BLOCK 37

DESIGN REVIEW

CASE # LU 14-117884 DZM

DESIGN REVIEW AUG. 21, 2014

WEST ELEVATION (SW River Parkway)

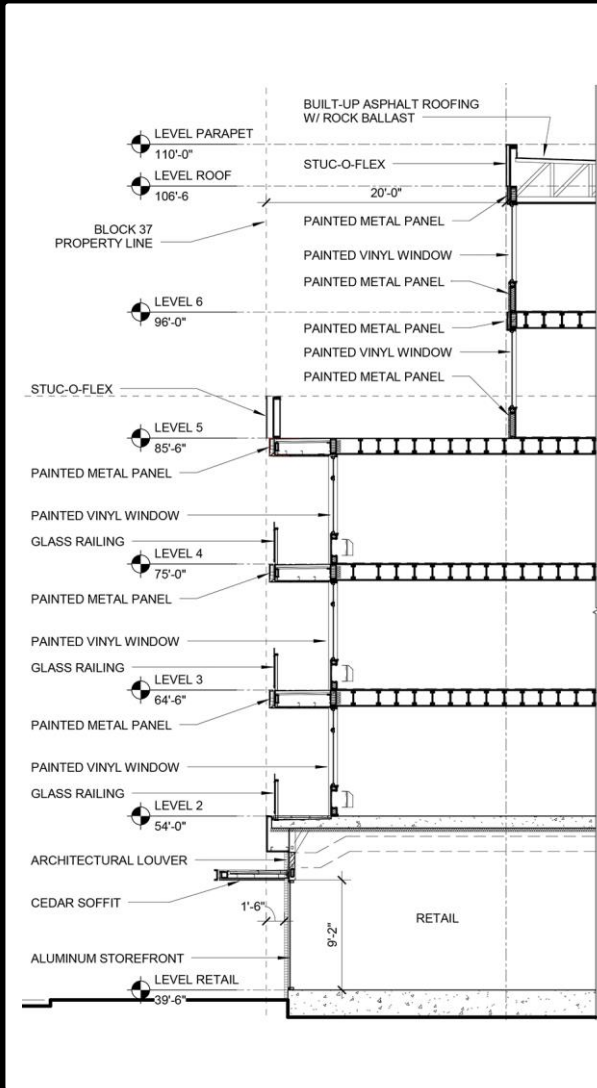
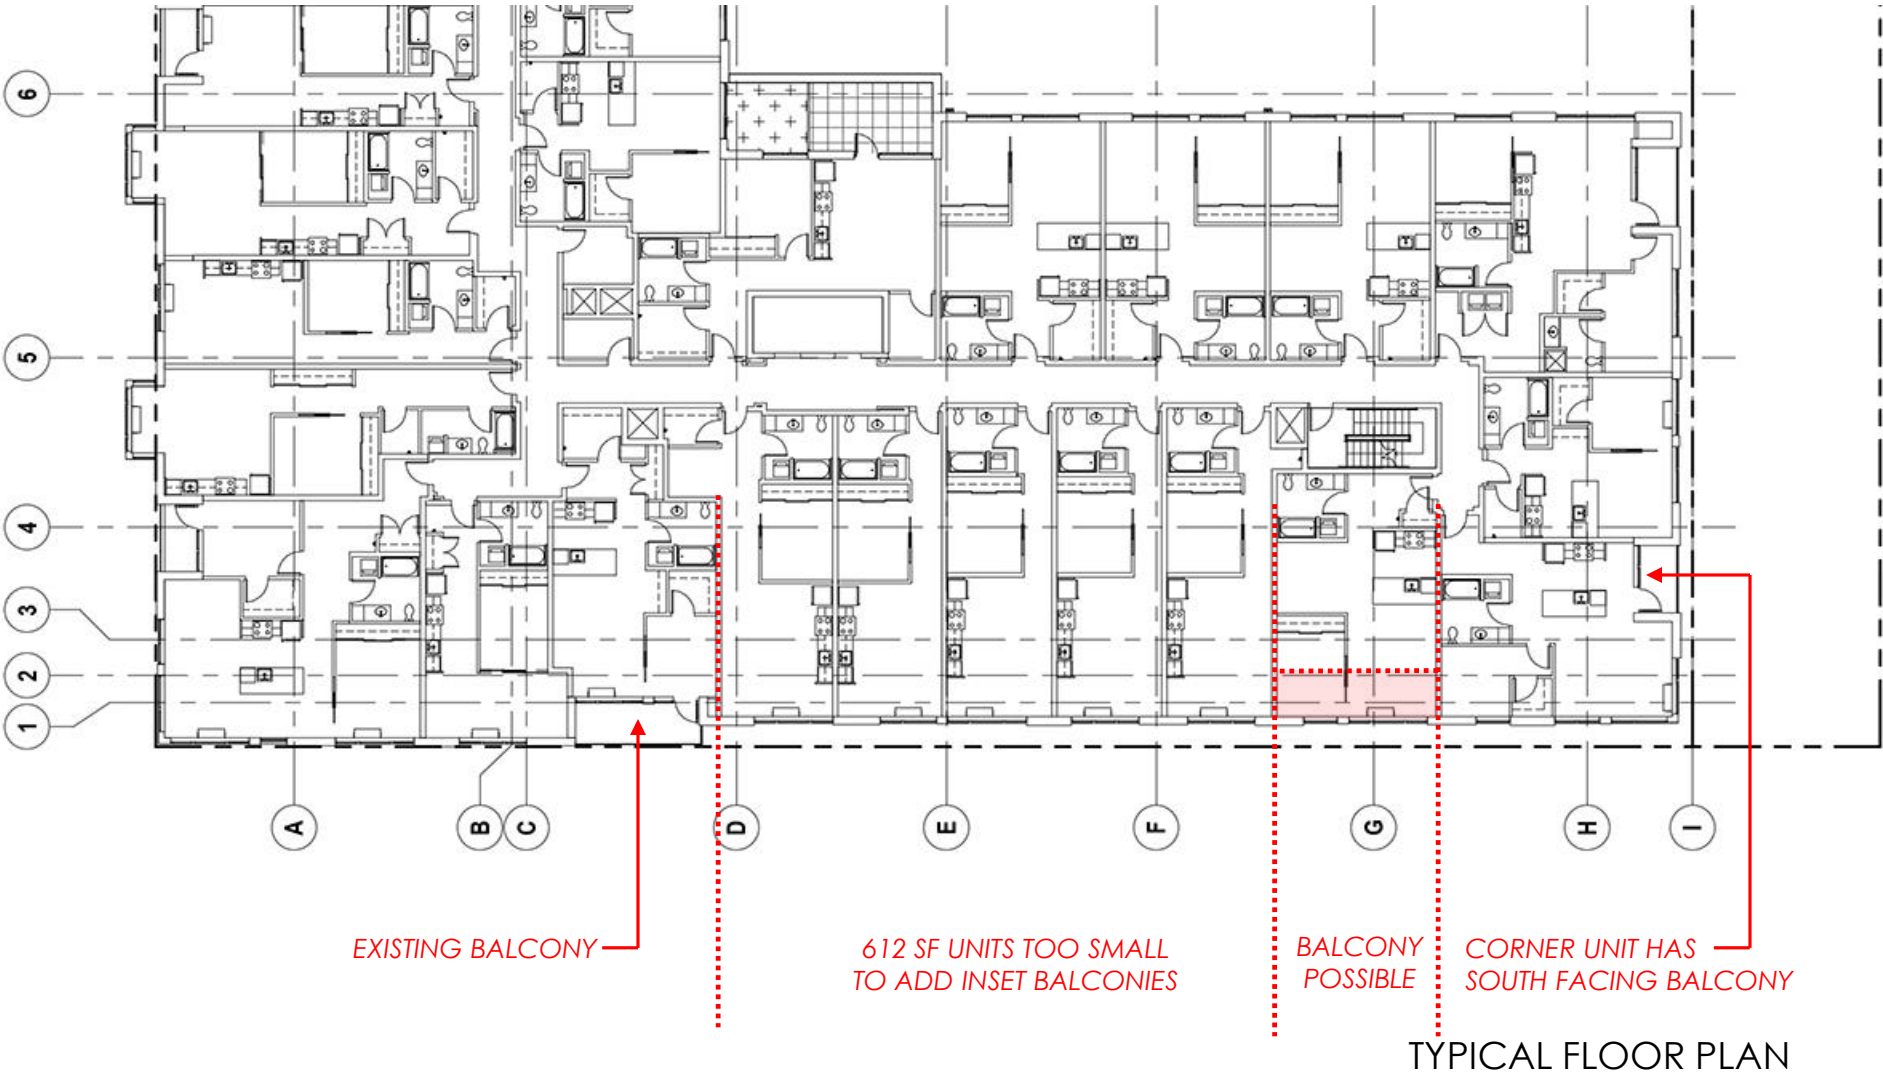
BALCONIES

(WEST FAÇADE)

SKETCH – WEST FAÇADE W/ ADDED BALCONY

DETAILS

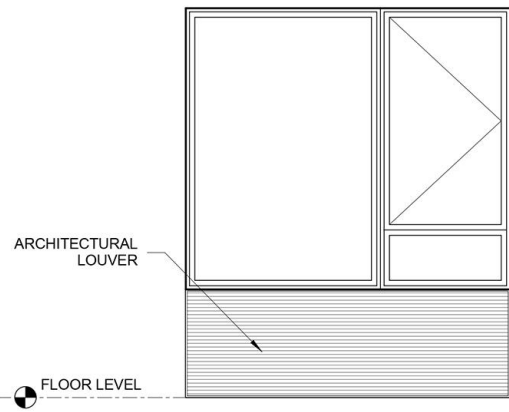
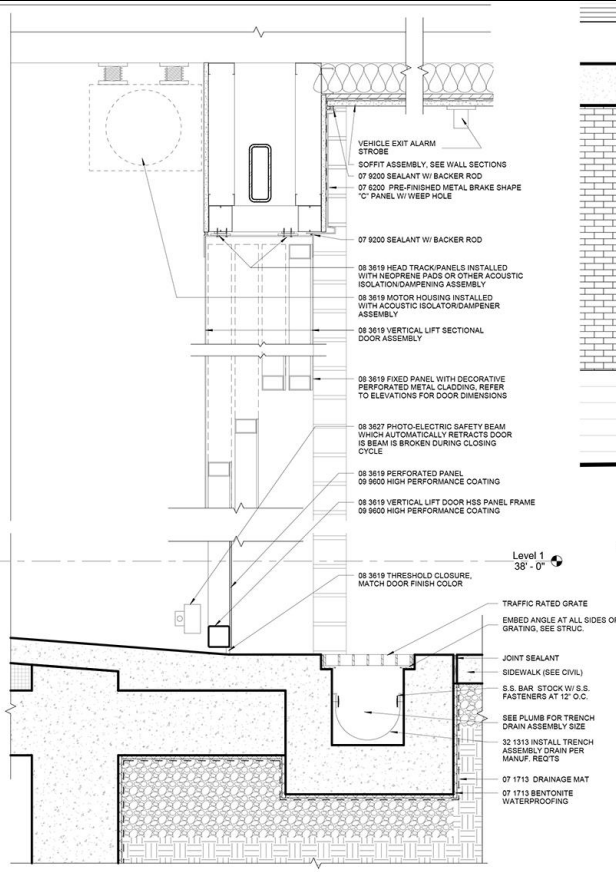
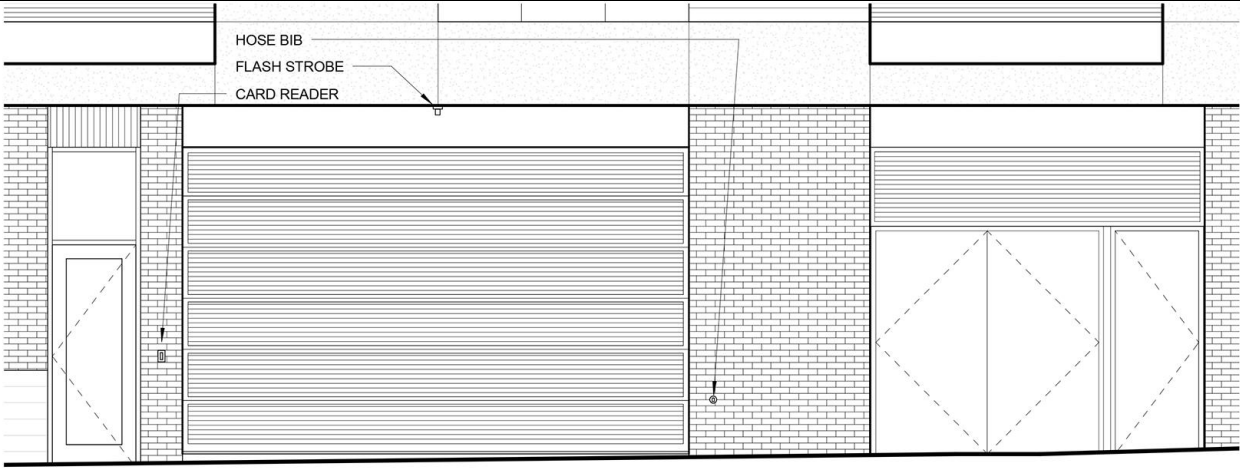
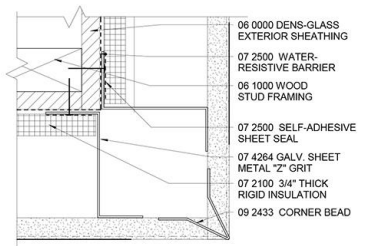
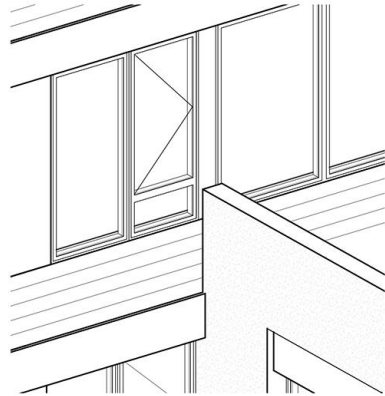
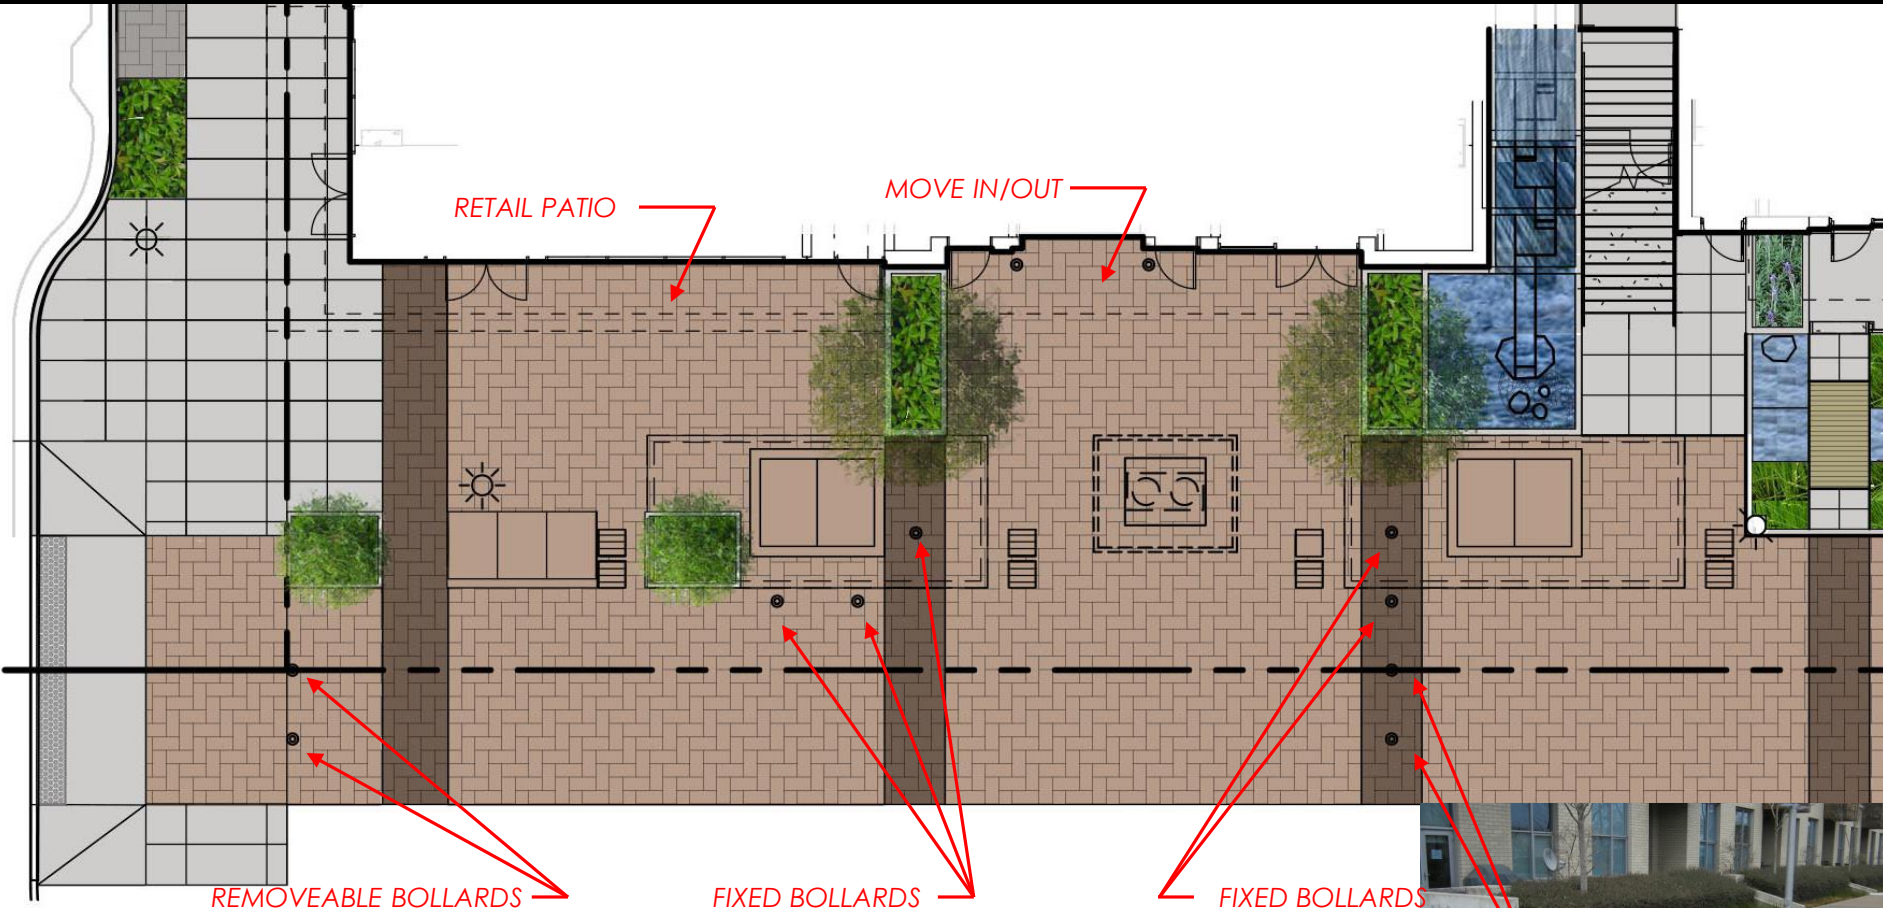
1. REVISE GARAGE ENTRY LOCATION
2. ADD BALCONIES TO THE NORTH ELEVATION. INSET BALCONIES PREFERRED
3. INCREASE SIZE OF RETAIL PATIO ALONG GREENWAY
4. IMPROVE MATERIAL COHERENCY AT THE NORTHEAST CORNER
5. ADD BALCONIES TO THE SOUTH ELEVATION. INSET BALCONIES PREFERRED
6. EXPLORE POTENTIAL FOR ADDITIONAL BALCONIES ALONG WEST FACADE.
7. PROVIDE ADDITIONAL DETAILS FOR LOUVERS, PARKING ENTRY AND BOLLARDS ON LANE ST.

2 TYPICAL PTAC LOUVER

4 VERTICAL LIFT GARAGE DOOR SECTION @ PARKING ENTRANCE
1/12" = 1'-0"

LANE ST. BOLLARD LOCATIONS
